Reference: A/18/8/PL for Application for Variation of Condition 2 imposed under A/173/16/PL to read "the development to be carried out in accordance with the following approved plans ADC962/04 REVA, ADC962/13 & ADC962/14 relating to revised position of rooflights on east, north 7 south elevations. This application affects the Character & Appearance of the Angmering Conservation Area at Land Rear of 1 To 6 The Cottrells Angmering

Location: Land Rear of 1 to 6 The Cottrells, Angmering

Inaccuracies and Inconsistency on Plans

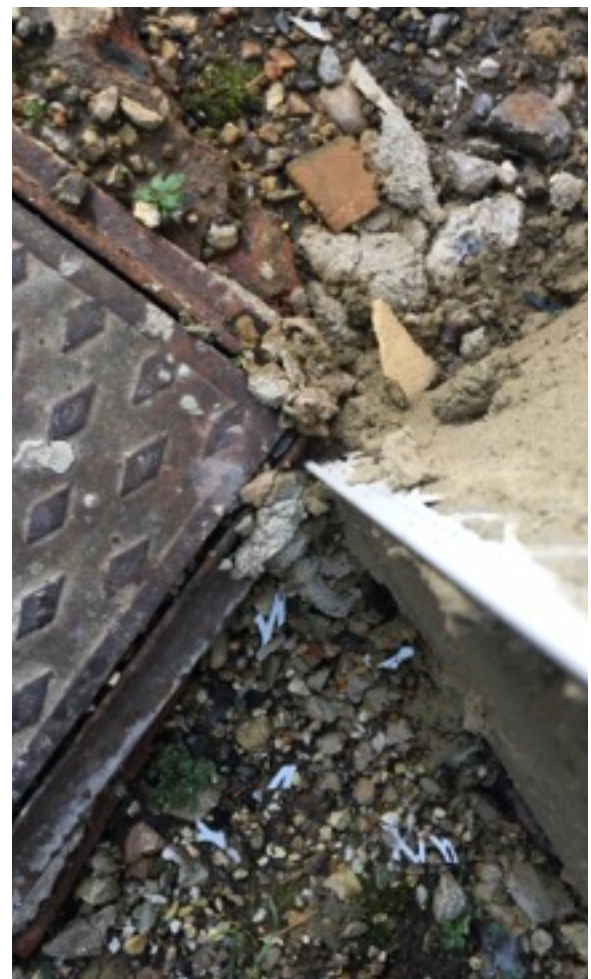
The below photographs taken from The Cottrells road, the shared alley way at the rear of No.s 1-5 of The Cottrells and from ground level and first floor level on my property. They show the towering and domineering nature of the building under construction.

Although I am not an architect or surveyor, I do not believe that the currently constructed roof ridge and the current west elevation window position would allow for a hip to be constructed without the roof and guttering overhanging my property. To achieve the hip end I believe the roof ridge needs to be reduced.

The below photographs also demonstrate the domineering nature of the whole development. It is shoe horned into a small site, I have to ask how is it that a two bedroomed apartment has the appearance of being larger than the neighbouring five two / three bedroomed houses? This has an adverse impact on the neighbouring properties and blocks light from some of the properties including those stretching beyond the new development's boundaries.

I request that the roof is taken back to the hip end the original approved application (A/173/16/PL) and the positioning of the building to be considered so that there is no overhang over the site's boundaries and all future maintenance can be achieved from within the site itself.
